Access Compliance Report

Public Rights-of-Way

Intersection ID: 21064	Main Street: BASS_LN	Cross Street: EDMORE_CT	Location: SE
ADA ID: 5E1AE40BAEAC	Ramp Type: PerpDiag	Initial Pass/Fail: Fail	Overall Compliance: No
		Severity Score: 25

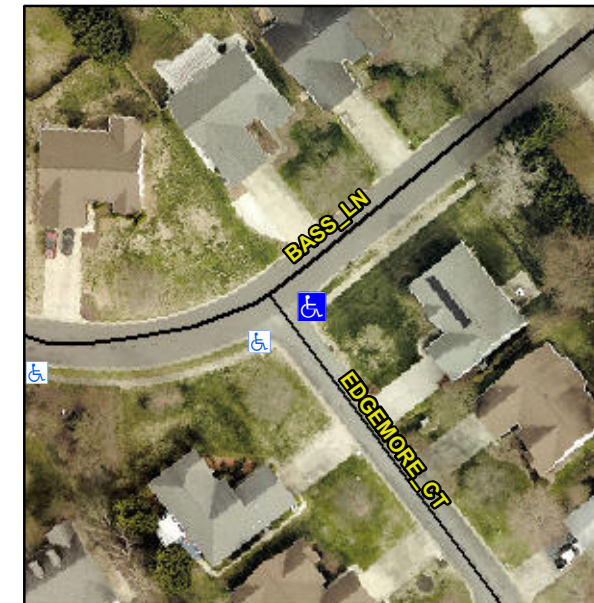
Not Found, R304.2.2, R304.5.3

Compliance	Description	Data	Compliance	Description	Data
N/A	Ramp Length (in)	39.0	No	Ramp Slope (%)	8.5
Yes	Ramp Width (in)	48.0	No	Ramp XSlope (%)	5.1
N/A	Flare Type LT	N/A	N/A	Flare Type RT	N/A
N/A	Flare Slope LT (%)	N/A	N/A	Flare Slope RT (%)	N/A
N/A	Flare Traversable LT?	N/A	N/A	Flare Traversable RT?	N/A
N/A	Landing Length (in)	N/A	N/A	DWS Provided?	N/A
N/A	Landing Width (in)	N/A	N/A	DWS Contrast?	N/A
N/A	Landing Slope (%)	N/A	N/A	DWS Length (in)	N/A
N/A	Landing X Slope (%)	N/A	N/A	DWS Full Width?	N/A
N/A	Landing Curb? (Y/N)	N/A	N/A	DWS Offset (in)	N/A
N/A	Shared Landing?	N/A			
N/A	Gutter Ponding?	N/A	N/A	Gutter Slope (%)	N/A
N/A	Gutter Lip Ht (in)	N/A	N/A	Gutter X Slope (%)	N/A
N/A	Painted X Walk1?	No	N/A	Painted X Walk2?	No
	X Walk 1 Direction	To N		X Walk 2 Direction	To SW
N/A	X Walk 1 Width (in)	N/A	N/A	X Walk 2 Width (in)	N/A
	X Walk 1 Slope (%)	1.8		X Walk 2 Slope (%)	2.7
	X Walk 1 X Slope (%)	2.3		X Walk 2 X Slope (%)	3.2

Remove & Replace Curb Ramp With Two New Directional Ramps or Equivalent.
